PLANNING AND BUILDING DEPARTMENT PLANNING DIVISION

July 5, 2023

Re: Building Permit Application No. 0361780, AN 117-210-061-000

Figure 3.2.A

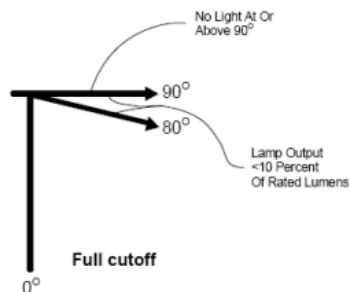
- a. Please provide highlighted cutsheets that identify which fixtures and their associated add-ons if any. I was unable to find within the cutsheets information that demonstrate all fixtures meet the full cutoff definition.

“Full-cutoff (fco)” means the light distribution of a luminaire where zero units of light intensity occurs at an angle of 90 degrees and greater above nadir, which is the vertical point directly below the luminaire when it is pointed down (0 degrees), and does not exceed 10 percent of lumen output at a vertical angle of 80 degrees above nadir, as demonstrated in Figure 3.2.A, below. This applies to all lateral angles around the installed luminaire to include any tilt or other non-level mounting condition. [Illuminating Engineering Society of North America (IESNA) Standards]. Full cut-off does not have the same meaning as and cannot be used interchangeably with the terms ‘cut-off’, ‘full shielding’ or ‘fully shielded’.
